Product Advisory

September 2012

M262-WAKE	6.5" Wakeboard Tower Speaker
M262B-WAKE	6.5" Wakeboard Tower Speaker Black
M282-WAKE	8" Wakeboard Tower Speaker
M262B-WAKE	8" Wakeboard Tower Speaker Black

Top Fracture Caused by Over Tightening

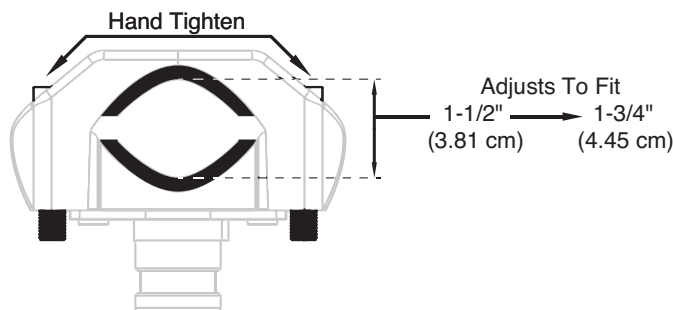
Over tightening cast aluminum wake tower clamps can cause one or more of the brackets to crack, possibly resulting in breakage. Unlike stamped metal, cast aluminum does not continue to bend when stretched beyond its forged design, and may bend slightly (if any) before cracking entirely.

1. Ensure correct rubber bushings are used for desired bar thickness.
2. Secure clamps **by hand tightening (8 Foot Pounds)**. Hand tightening the top main allen screws using enclosed Allen Wrench is highly recommended and likely alleviate over-tightening.
